ALTO PRODUCTS CORP.

New Product Release / Alto Kit # 049681HP Ford AOD / AODE / 4R70W Intermediate One-Way Clutch Retainer Snap Ring

Fig #1 - OE Configuration

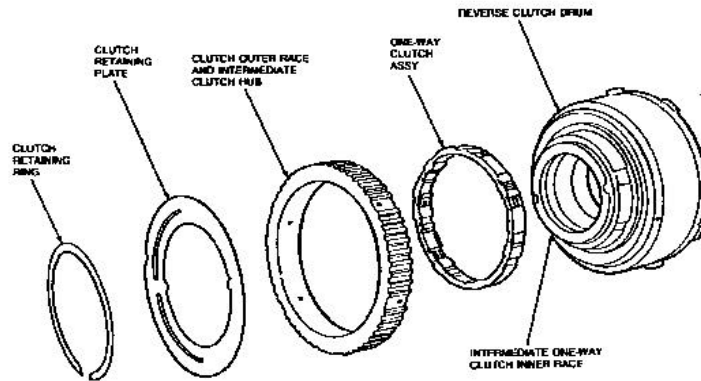
Problem: The traditional style OEM snap ring retaining the intermediate one-way clutch to the direct drum distorts and allows the one-way clutch retainer to come loose. This causes catastrophic damage to the transmission.

Solution: Install Alto Products Corp. 049254 spiral snap ring and the snap ring retainer 049254A. This will insure that the intermediate sprag retainer will be held in place.
